## ISAF Equipment Rules of Sailing Question and Answer Service

### G.5.5 Q&A 2012-001

Published: 23 January 2012

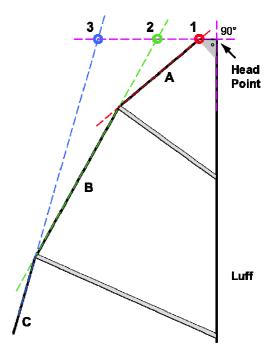
Which one of 1, 2 or 3 is the **aft head point** in this diagram?

"A", "B" and "C" are all parts of the **leech** and the **aft head point** shall be taken at the point where the extension of "A" intersects with the line through the **head point** and 90° to the **luff**.

"1" is the aft head point in this case.

Applicable ERS rules: G.4.2 and G.5.5
